MIL "ON" DTC P07407E

Service Category Drivetrain

Section Automatic Transmission/Transaxle

YEAR(S)	MODEL(S)	ADDITIONAL INFORMATION
2018	Camry

Figure 1. Location of Authorized Modifications Label on 2018 Camry

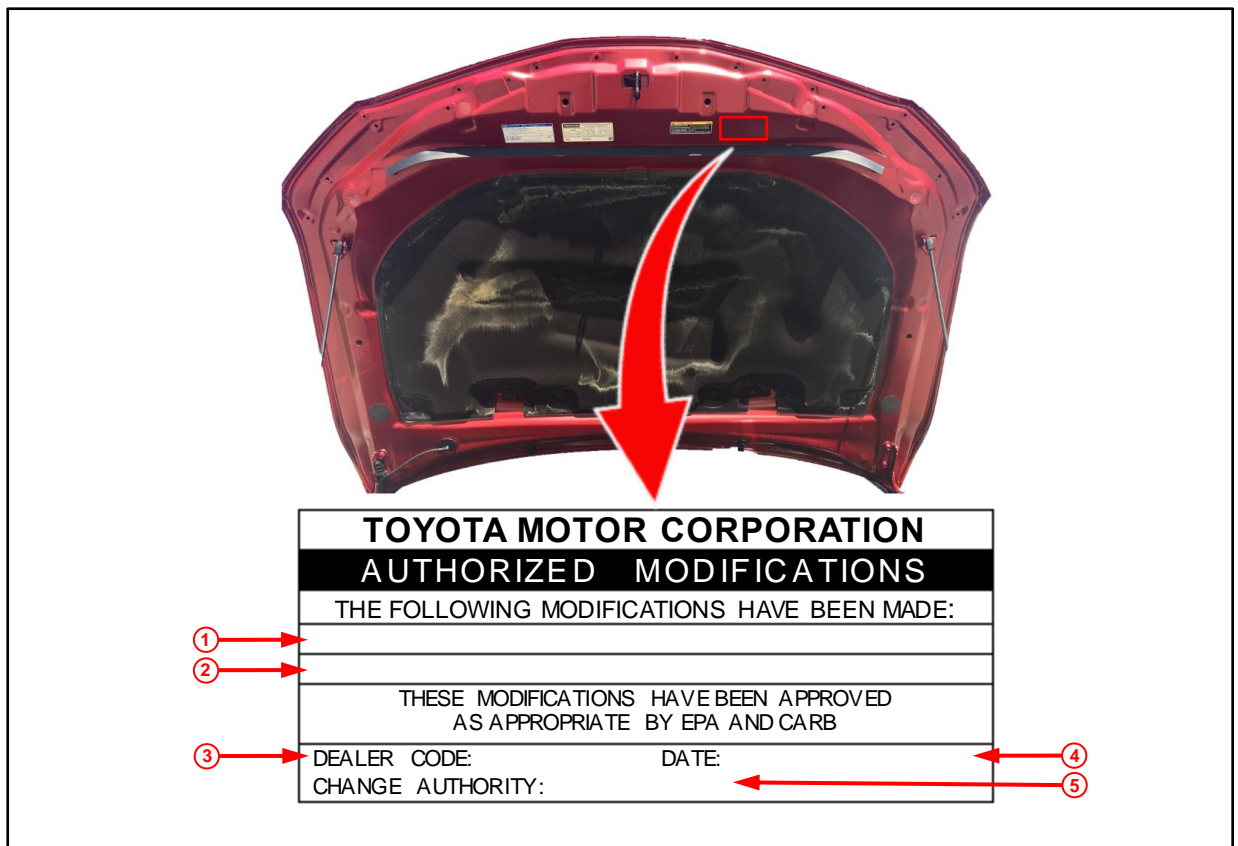
2. Check for the Authorized Modifications Label affixed to the vehicle in the location shown below. Confirm if the ECM (PCM) calibration has been updated.

- Prepare and install the Authorized Modifications Label.
 - Using a permanent marker, enter the following information on the label:
 - ECM (PCM) part number [*Refer to the **Parts Information** section for the **NEW PART NUMBER***]
 - Calibration ID(s) [*Refer to the **Calibration Information** section for the **NEW CALIBRATION ID***]
 - Dealer Code
 - Repair Date
 - Change Authority [***This bulletin number***]
 - Affix the Authorized Modifications Label to the vehicle at the location shown in Figure 1. The Authorized Modifications Label is available through the MDC, P/N 00451-00001-LBL.
- Test drive the vehicle to confirm proper vehicle operation.
